P 516410

## ON-SITE SEWAGE DISPOSAL SYSTEM HOWARD COUNTY HEALTH DEPARTMENT BUREAU OF ENVIRONMENTAL HEALTH

SUBDIVISION: Foxhall Villas LOT NUMBER: 5

ADDRESS: 13301 Elliott Drive PROPERTY OWNER: Suneel Bharowaj

**TRENCH DATA**

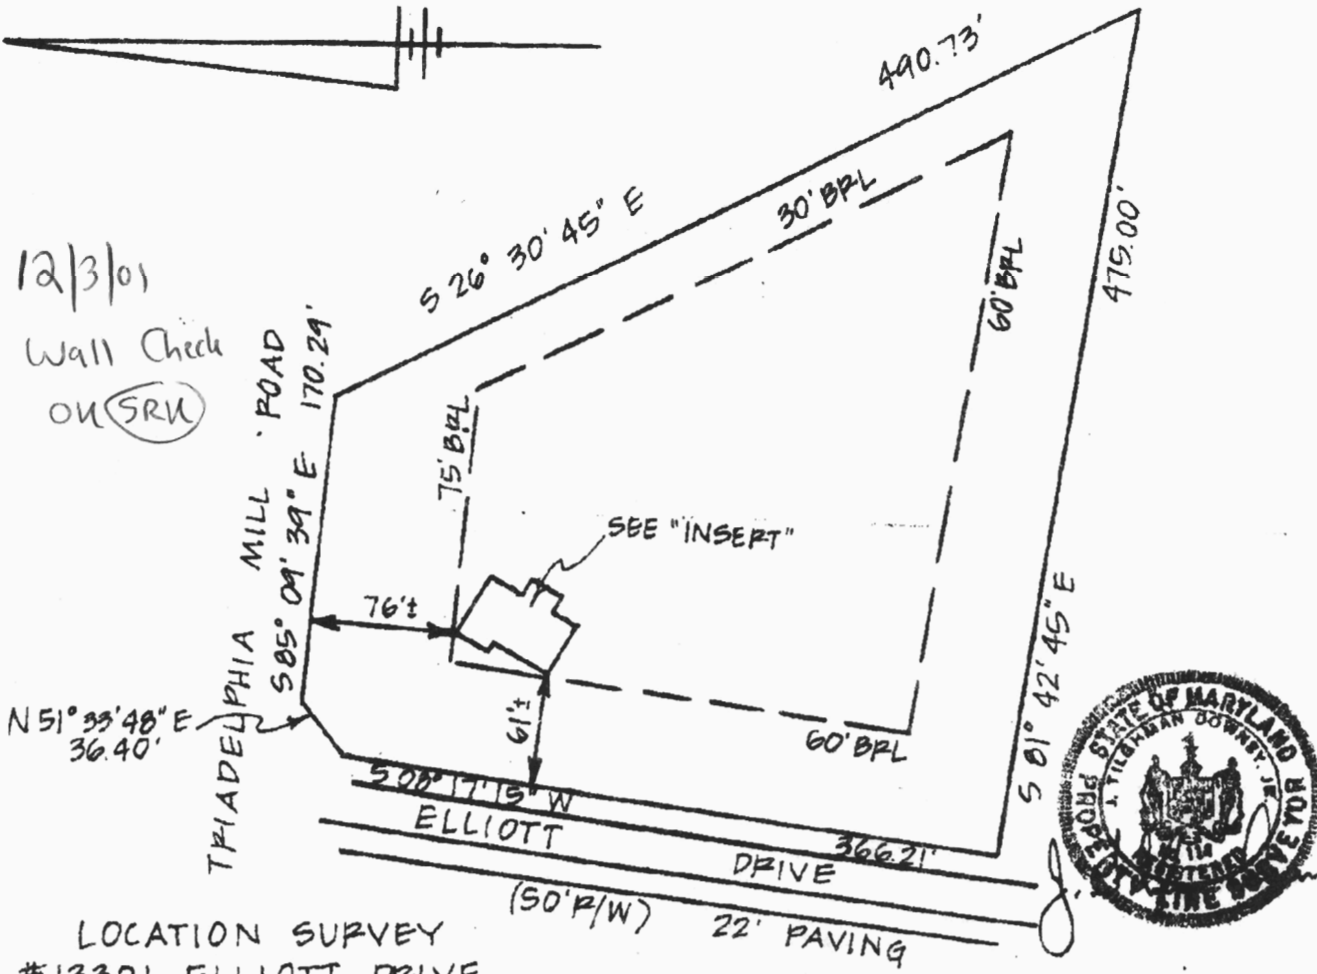
PRE-CONSTRUCTION INSPECTION: 12/3/01 - 10' CTC, *changed location of tank & D.B.* (signature) ON SRU

INSPECTION COMMENTS: 12/3/01 Tank set, OK to cover well line for access to backyard (signature) 12/7/01 Two trenches in 12/7/01 OK to cover all work Signed permit (signature)

PLOT PLAN  
ELLIOTT DRIVE  
LOT 5  
"FOXHALL VILLAS" 7019  
ELECTION DISTRICT N<sup>o</sup> 5  
HOWARD CO, MD  
SCALE: 1"=50'  
REVISED MAY 11, 2001  
01-8498  
REVISED MAY 22, 2001

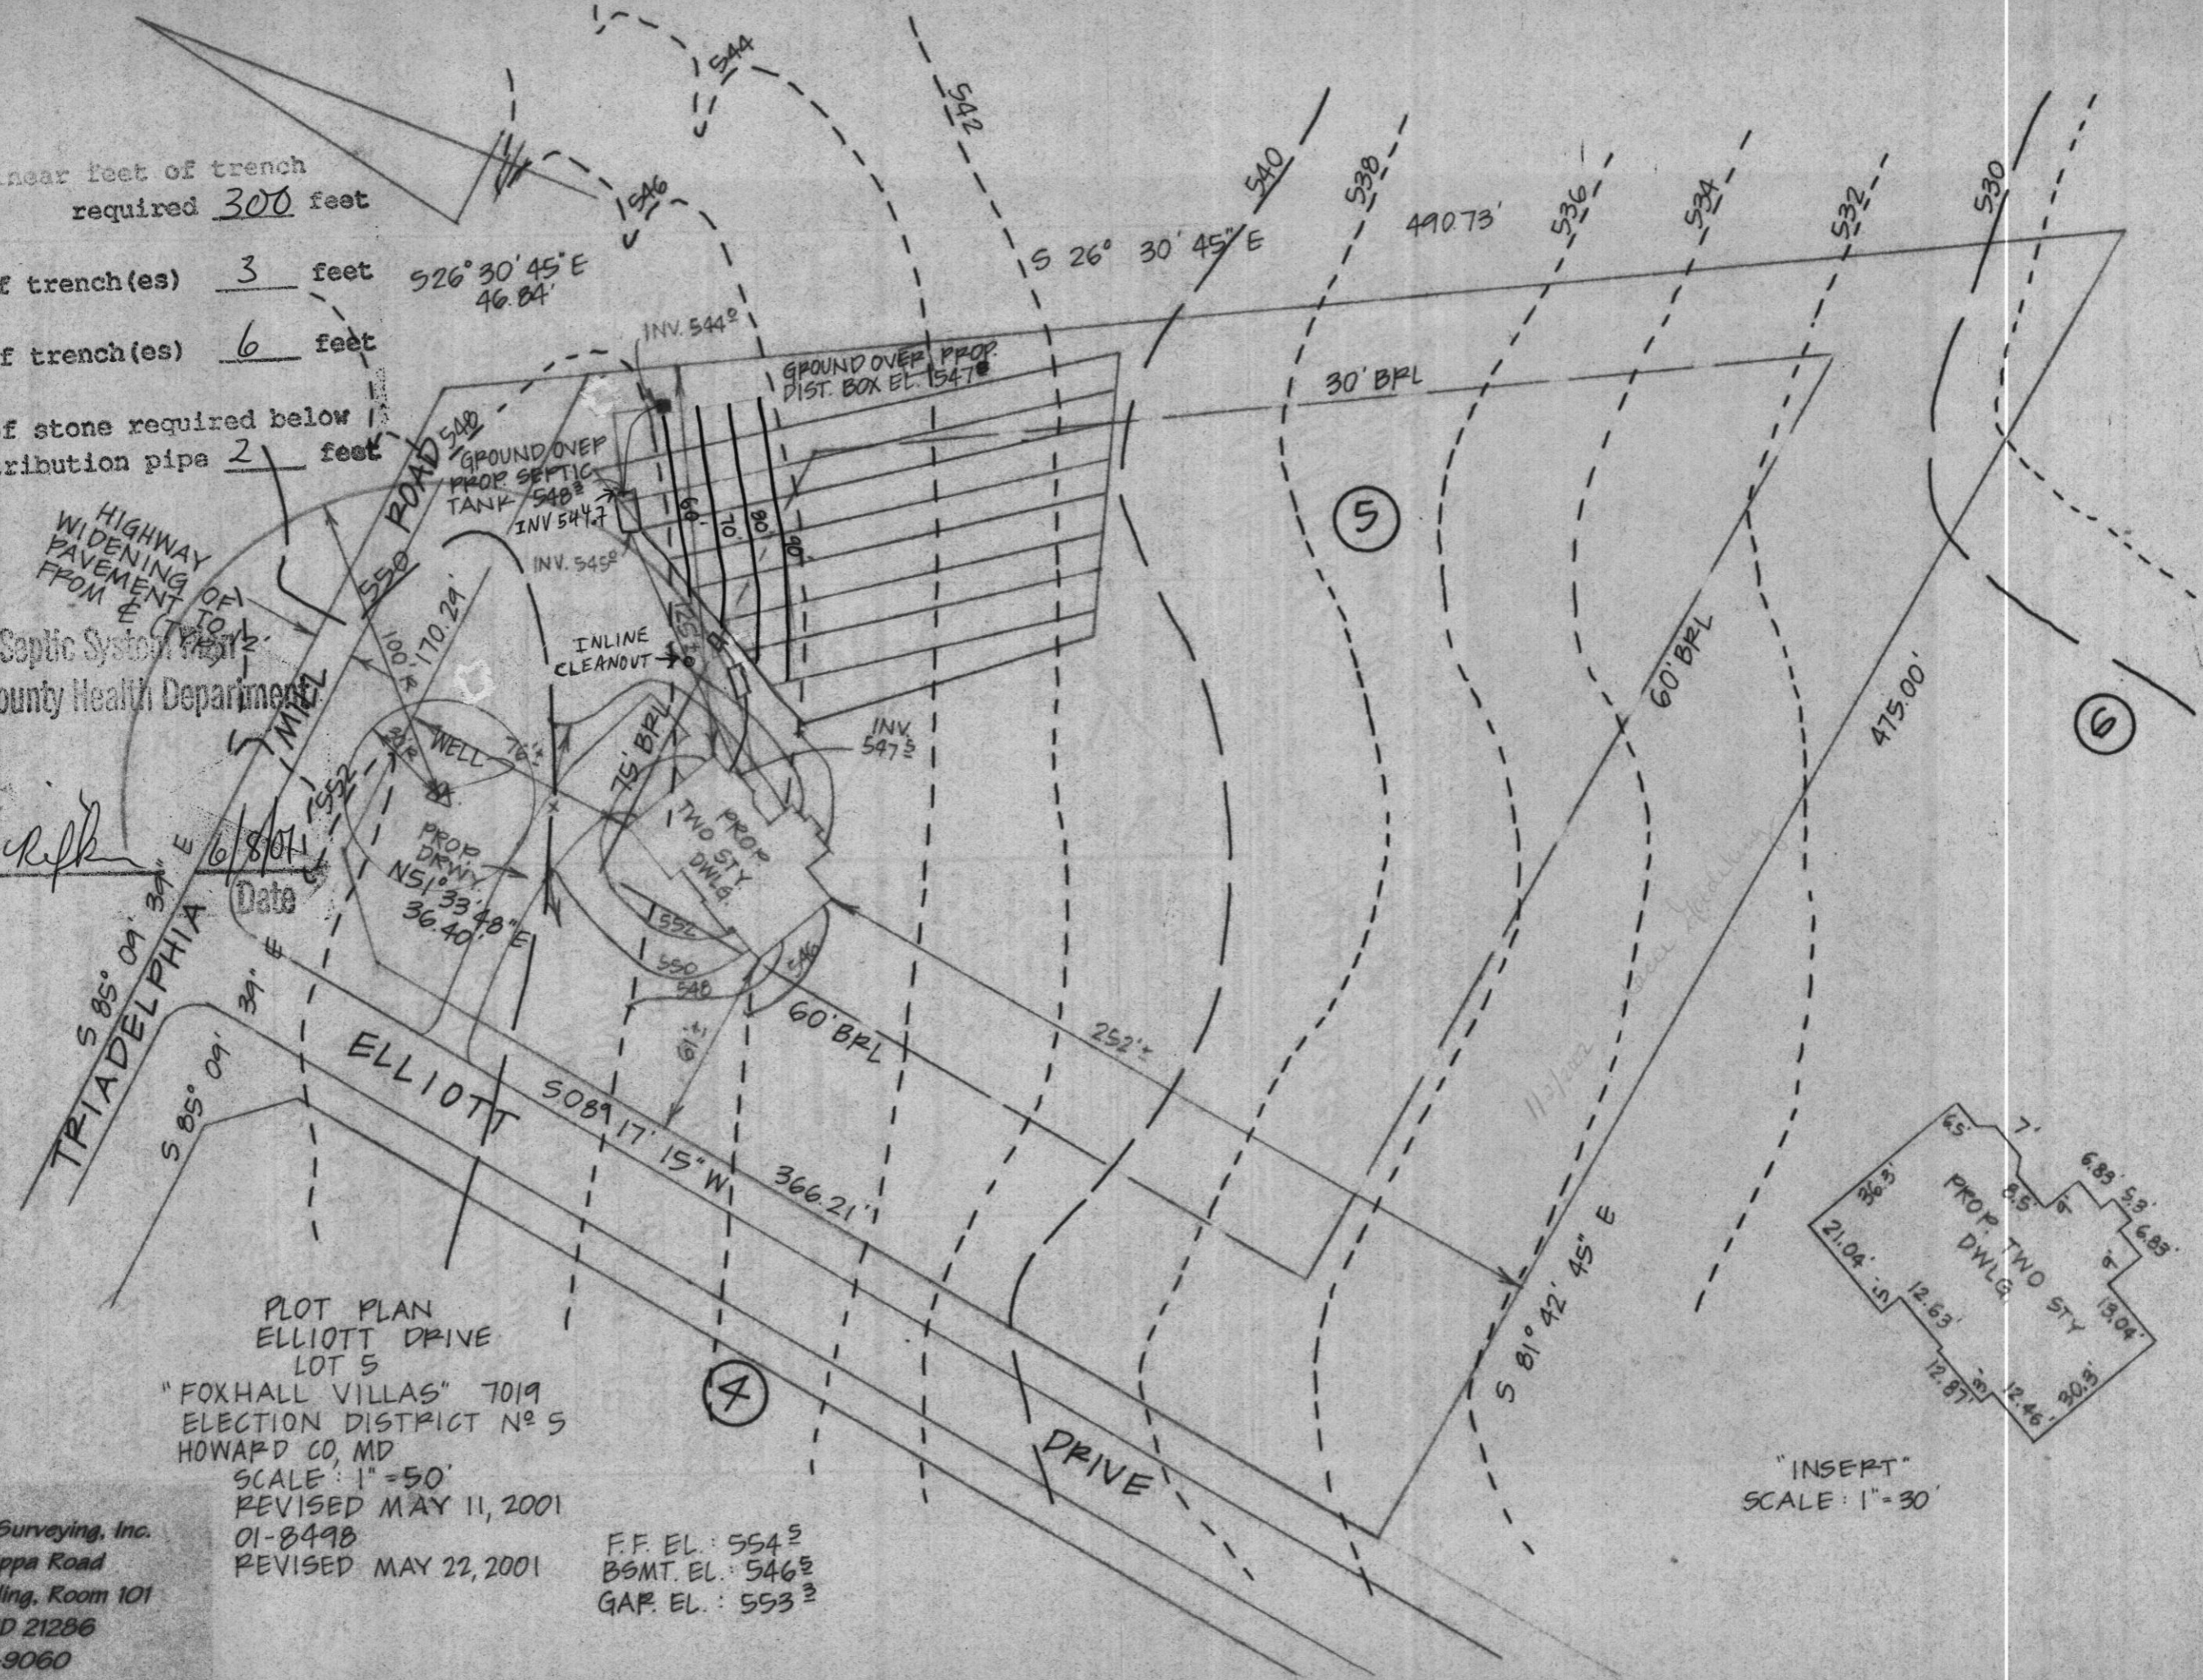
Approved Septic System Plan  
Howard County Health Department
